# ADA Curb Ramp New Construction Inspection Form (Perpendicular)

Nw 289

Nw union

## PERPENDICULAR RAMP (PR)

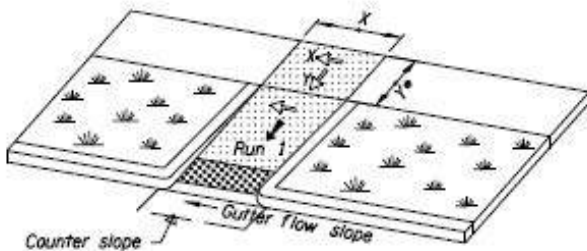
IITD RR1 fail
